ALBUQUERQUE FIRE MARSHAL'S
DIVISION OFFICE PLANS
CHECKING DIVISION
PERMIT
PERMIT NUMBER: FP-21-007302
APPROVED DATE: 08/26/21

ENGINEER'S SEAL	3-BAY OIL CHANGE	DRAWN BY LN
	5400 MENAUL BLVD NE	DATE 08/17/2021
	FIRE 1	FIREONEPLAN
	TERRA WEST, LLC 5571 MIDWAY PARK PLACE NE ALBUQUERQUE, NM 87109 (505) 858-3100 www.tierrowestllc.com	SHEET # F1
		JOB # 2021077

ENGINEER'S SEAL	3-BAY OIL CHANGE	DRAWN BY LN
	5400 MENAUL BLVD NE	DATE 08/26/2021
	TRAFFIC CIRCULATION LAYOUT	2021077-TCL
	TERRA WEST, LLC 5571 MIDWAY PARK PLACE NE ALBUQUERQUE, NM 87109 (505) 858-3100 www.tierrawestllc.com	SHEET # C1 JOB # 2021077

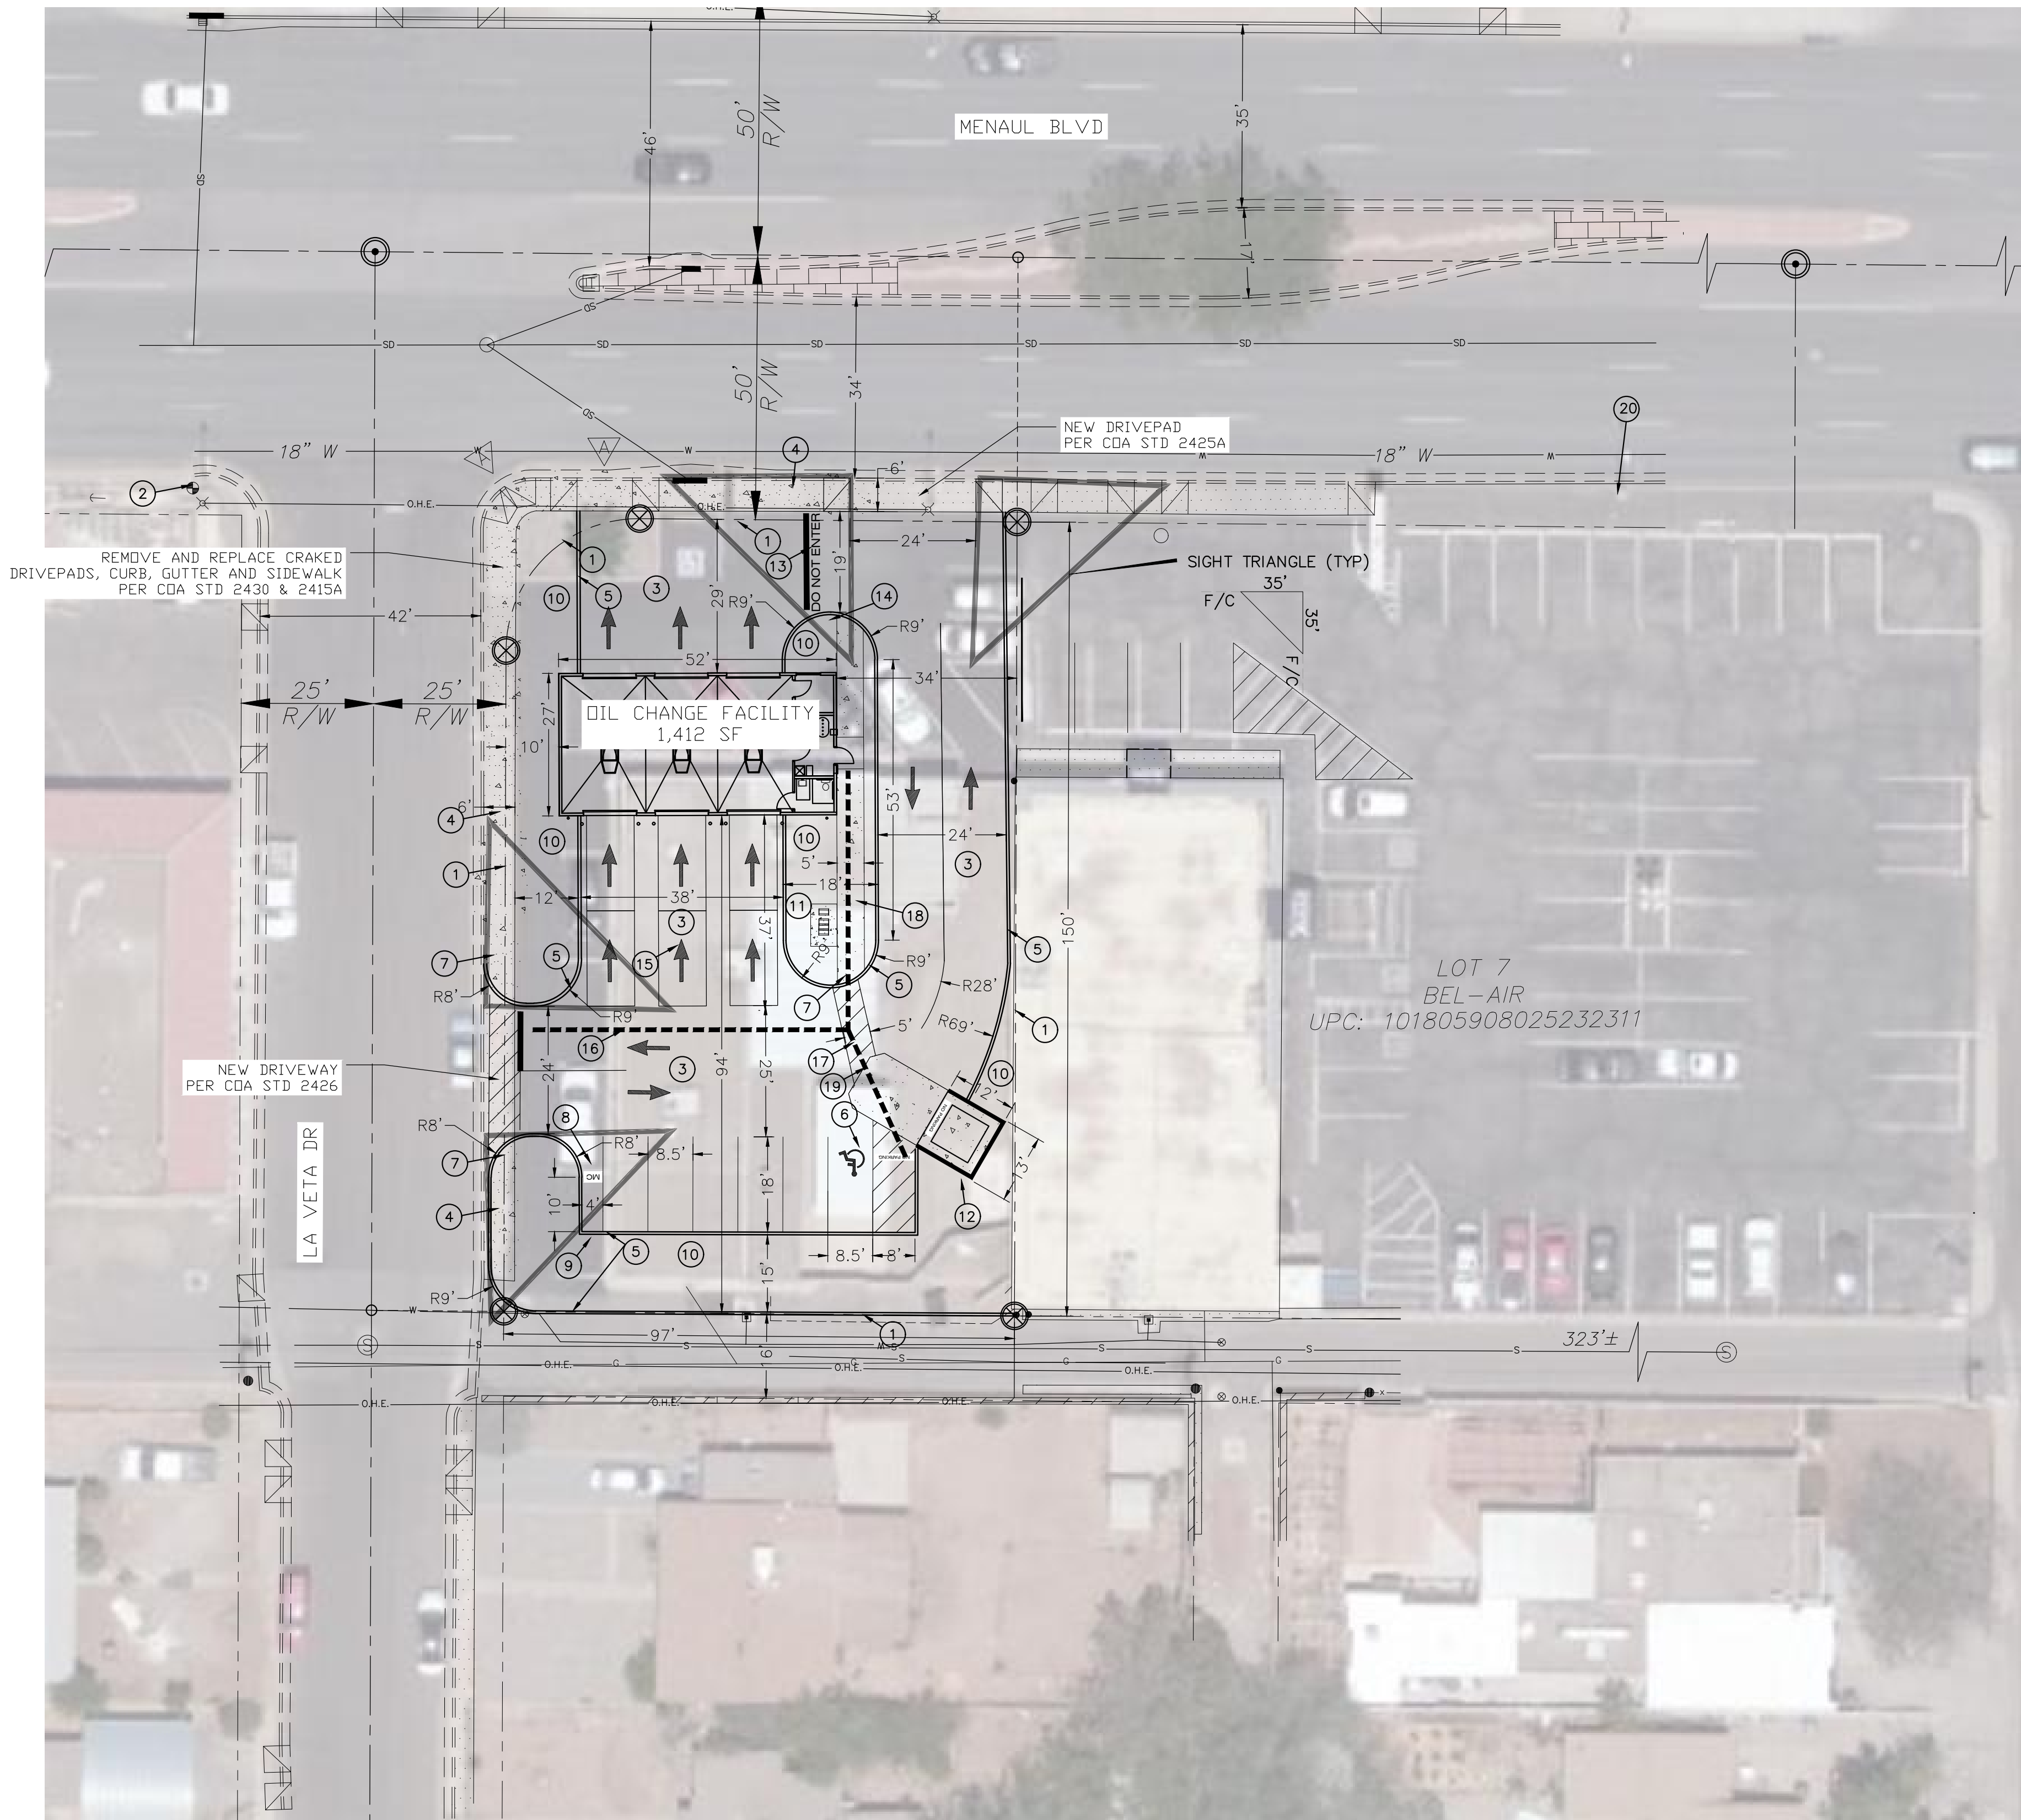
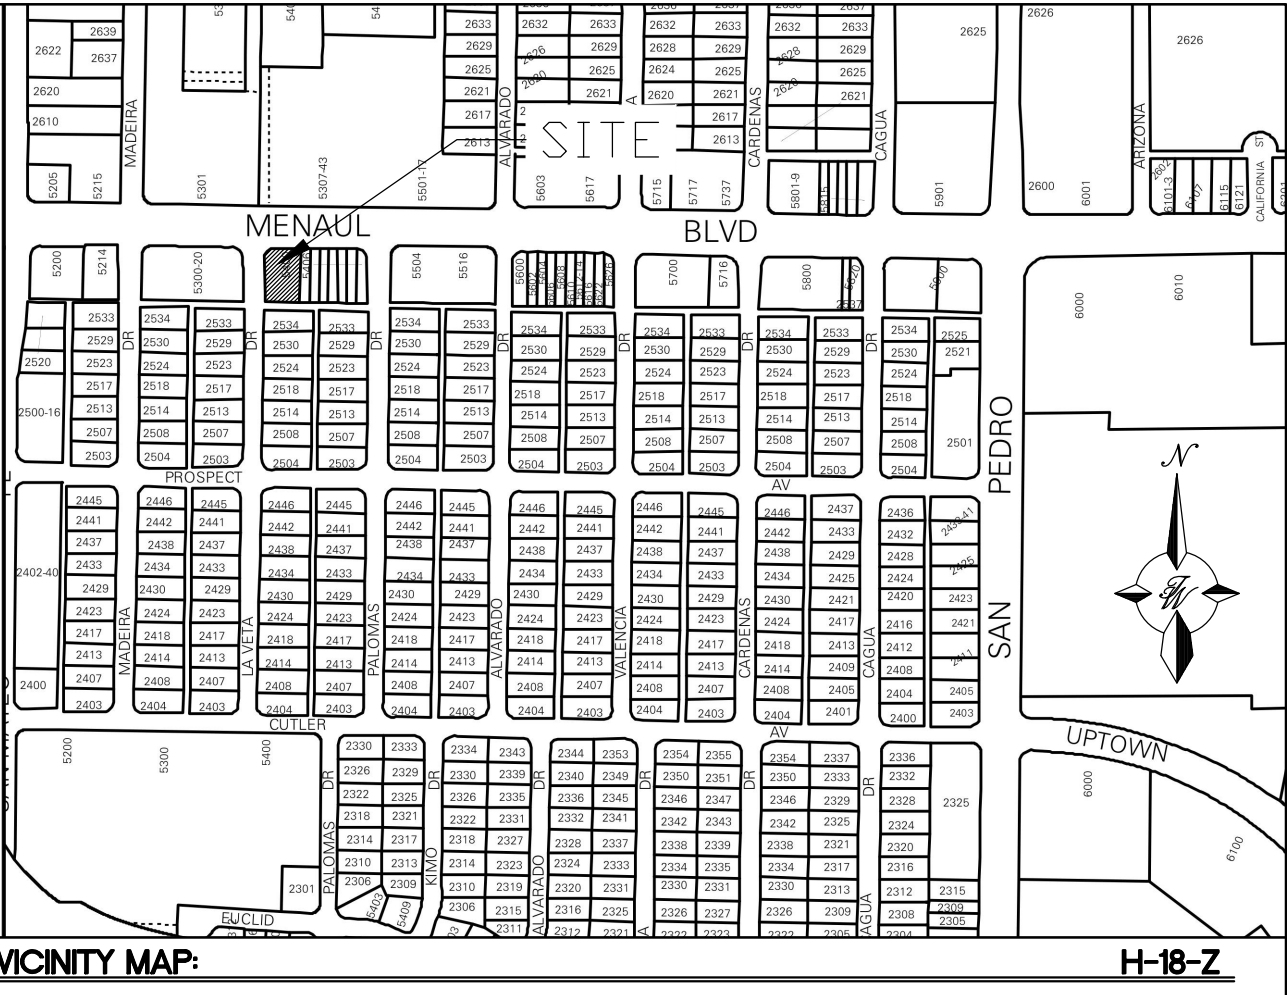
Approved for access by the Solid Waste Department
Herman Gallegos 08-27-21
Hazard Route Only
**Condition If slope exceeds 1/8" per foot leading to and in the
trash enclsoure this approval will be Void.**
